**RE: DA 1178/2017 - PROPOSED WOOLWORTHS DEVELOPMENT.
LOT 901 DP 1222132, GEORGE BOOTH DRIVE, CAMERON PARK.**

I refer to the abovementioned project, Council's request for information (RFI) by email dated 30 April 2018 and subsequent discussions with Council staff. This submission presents a formal response to the matters raised in Council's RFI.

DRAWING TITLE
DRAINAGE LAYOUT

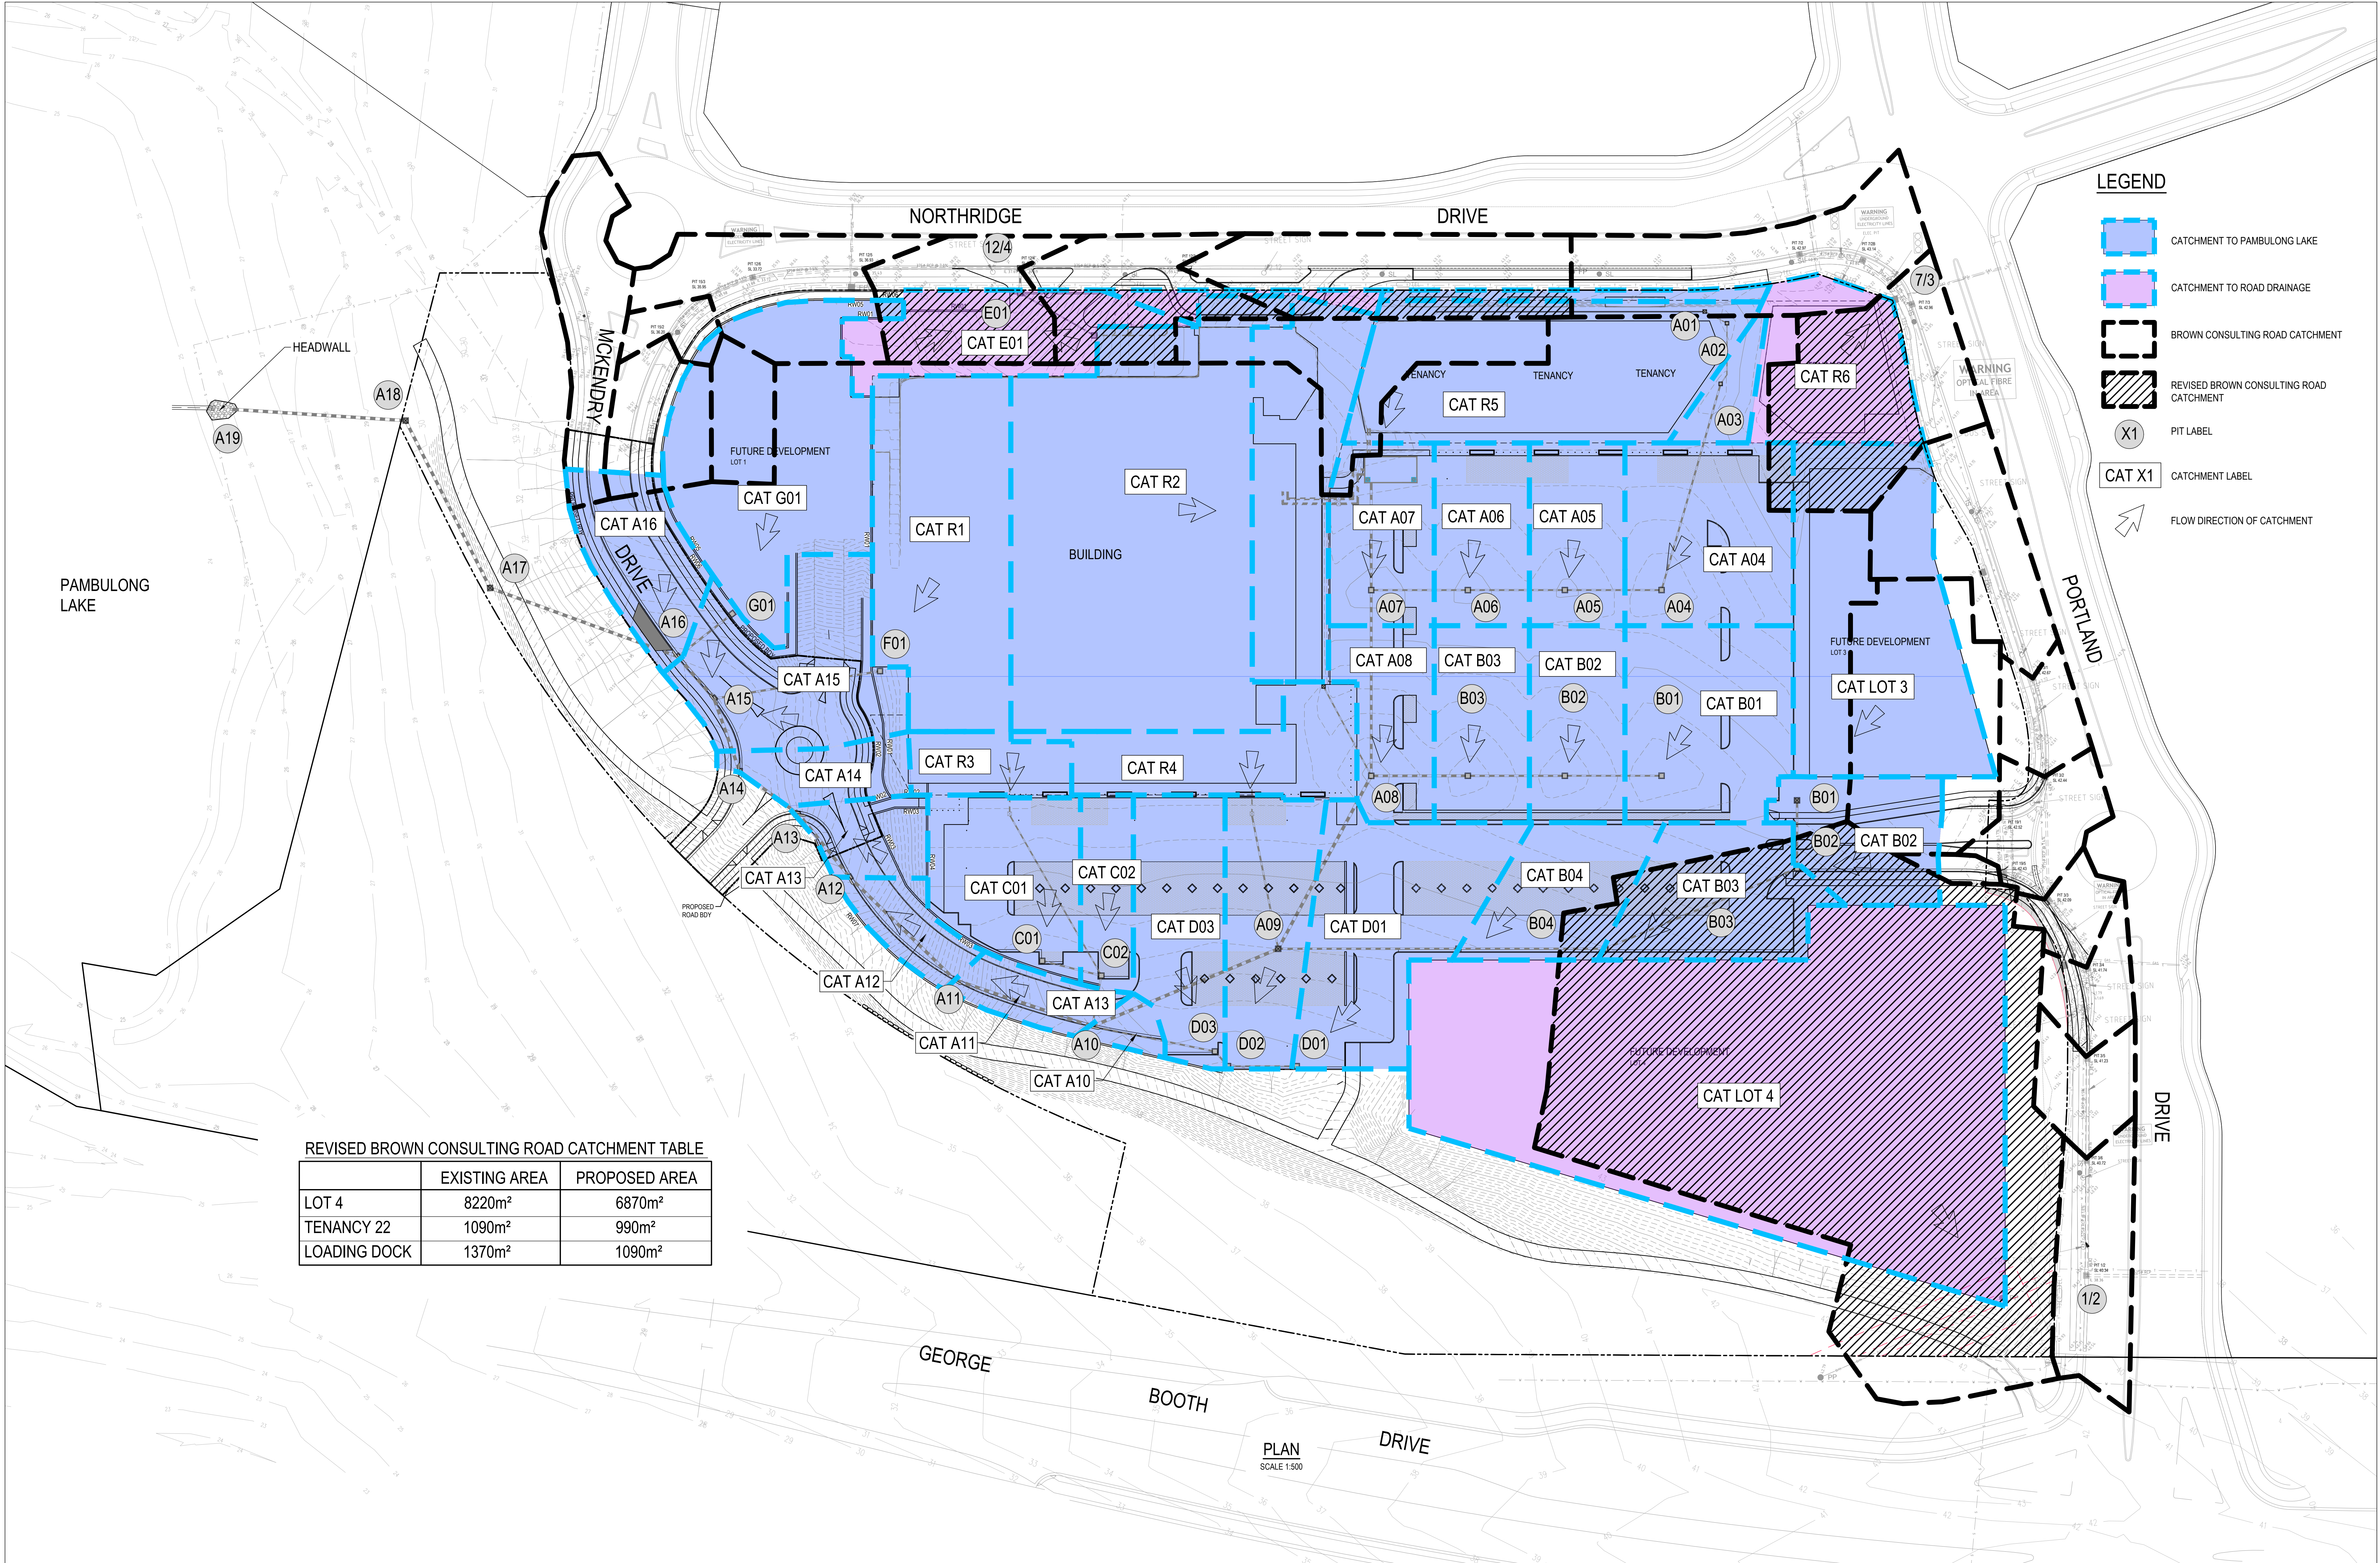
The landscape plan indicate remnant bushland fringing the south western perimeter fronting George Booth Drive. The engineering plans indicate a detention basin is proposed to be built fronting George Booth Drive. This is not supported for the above reasons. The proposed carpark is vast and can accommodate tanking, with already cleared areas at the corner with Portland Drive and west along George Booth Drive able to accommodate detention. Recommendation: integrate detention with landscape design and value visual amenity provided by existing remnant bushland.

The retaining basin included in the engineering plans adjacent to the heritage item has not been identified in any other plans. The impact of this basin and associated vegetation removal was not considered in the SHI. The retention basin should be integrated with landscaping and the impact on the adjacent cycleway/shared pathway needs to be addressed. The basin will most likely be fenced, which will have a detrimental impact on the cycleway, considering the close proximity. The bushland setting of the tramway should be retained as much as possible and any built elements that do not relate to the cycleway should be clearly separated.

The detention basin should be relocated to a different location, away from the cycleway, and the bushland setting retained.

As per Council's recommendation, the proponent has removed the proposed detention basin from the southern portion of the site. Accordingly, there will be no impact on the remnant vegetation.

Van der Meer Consulting has amended the drainage design (refer to the plans provided in **Appendix A**). The amended layout eliminates the need for an on-site detention basin by

ensuring that no catchments draining to Northridge Drive and Portland Drive are greater in size than those previously defined by the Brown Consulting engineering design.

We have amended the stormwater drainage layout as shown on our plan DAC401 Rev E attached. We have eliminated the need for an on-site detention basin by ensuring that no catchments draining to the Northridge and Portland Drive are greater in size than those previously defined by the Brown's engineering plans. Our plan DAC410 Rev D also attached shows the existing and proposed catchments together with a catchment comparison table.

DETAIL 2- CYCLEWAY INTERPRETIVE PATTERN PLAN

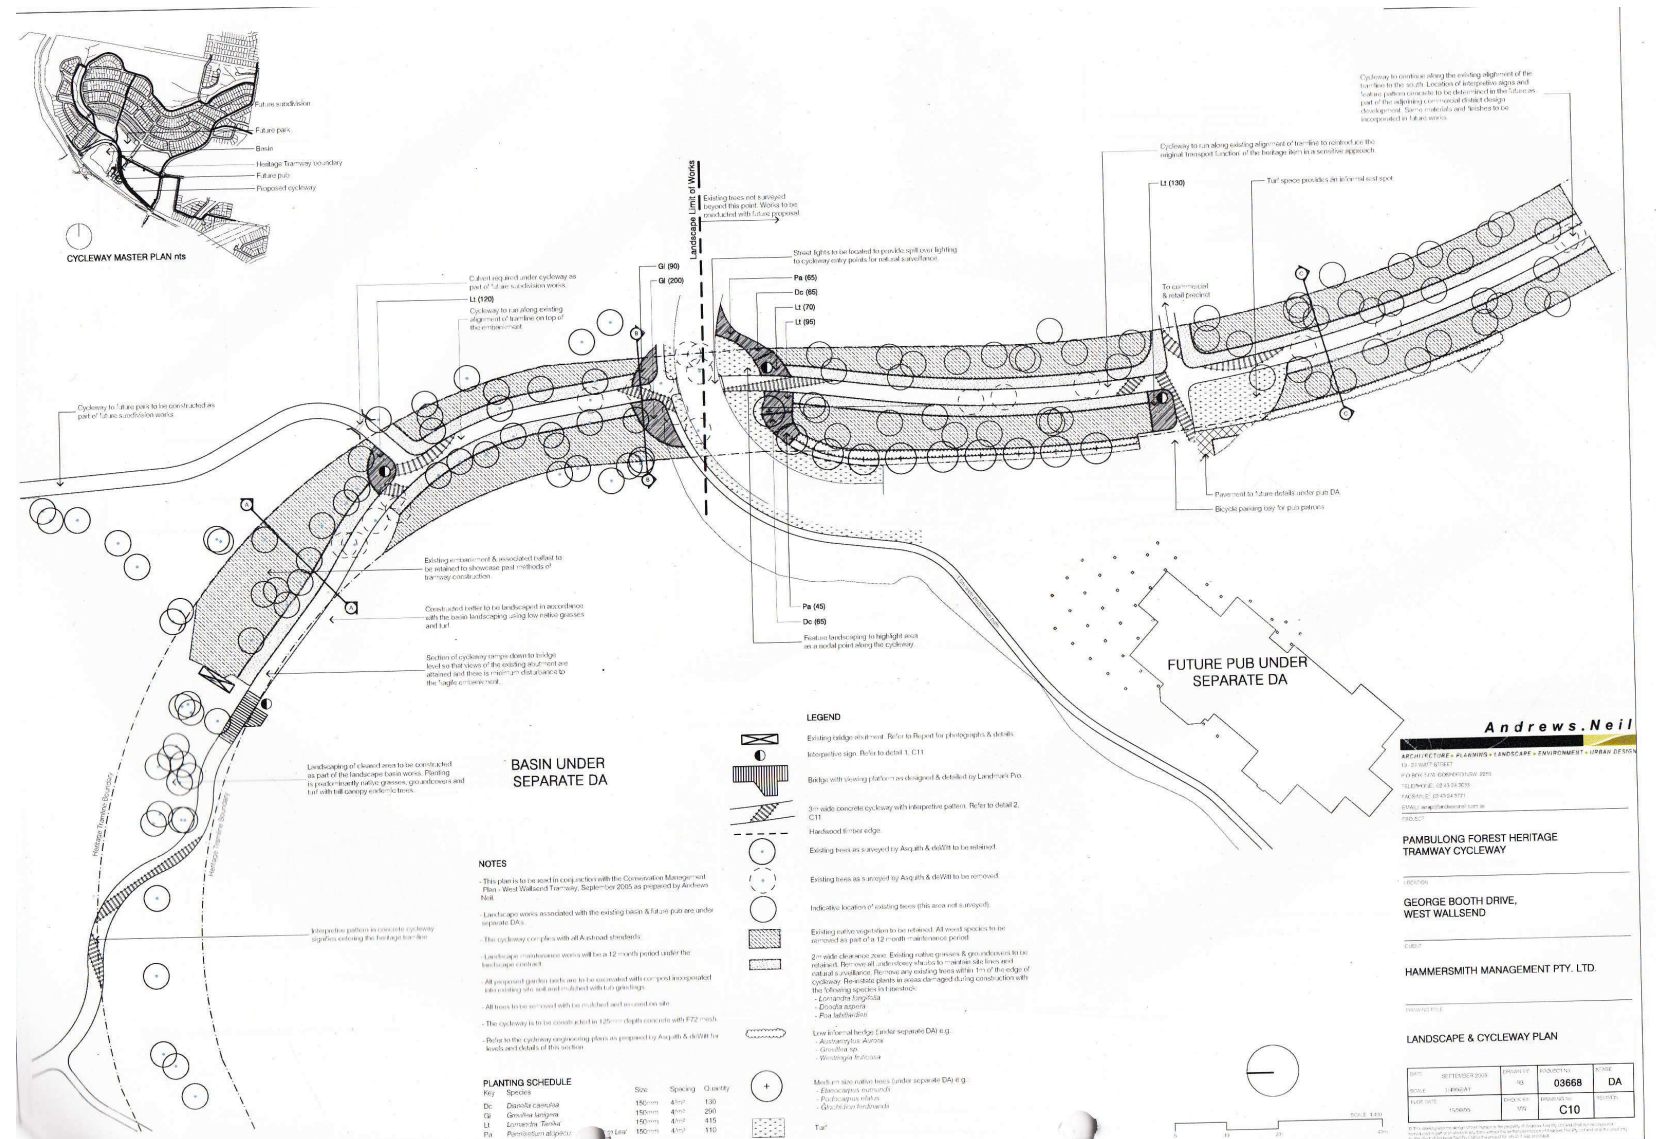
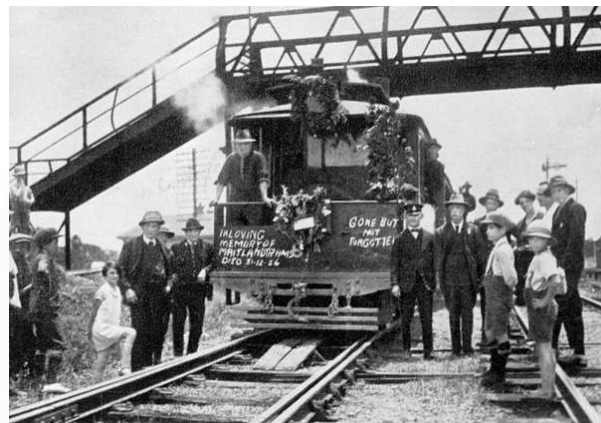
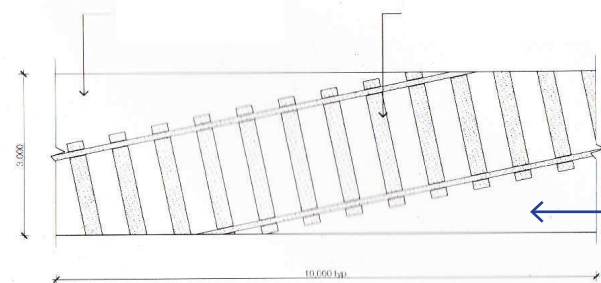
The submitted Statement of Environmental Effects (SoEE) states that details for the link have been provided in the revised architectural plans, however the only details provided are the width of the link, to comply with the West Wallsend Tramway Plan of Management. The landscape Plan, similarly, only mentions feature planting, with no further detail provided.

The applicant is to provide additional information detailing the link and how it articulates with landscaping and existing levels should be provided, as well as how the impact of the retaining walls will be ameliorated.

- Heritage interpretation internodes at various points along the cycleway as well as at the western pedestrian entry into the site inclusive of abrasive blast finished pathway treatment to the pattern of a tramway; and
- Heritage interpretation internodes at the north eastern corner of the site inclusive of pathway treatment (abrasive finish to create a tramway pattern) as well as opportunity for interpretive bench seating and signage.

- Additional detail has been provided in relation to the interpretive elements proposed to reference the steam tram line whilst traversing the cycleway. Interpretive paving patterns incorporated into the surface of the cycleway (located at the central link into the site and the link to the adjacent hotel site) are entirely consistent with the Plan of Management for the tramway; and

- Additional detail has also been provided in regards to the interpretation elements proposed to reference the former West Wallsend Steam Tram Line whilst traversing the approved cycleway. The details which are shown on the Landscape consultants' drawings directly reflect the intent and much of the detail of the Andrews Neil West Wallsend Tramway Plan of Management. Opportunity is provided for interpretive signage. Interpretive paving patterns incorporated into the surface of the cycleway have been shown in direct accordance with the Plan of Management and are located at the central link, and the link to the hotel site.
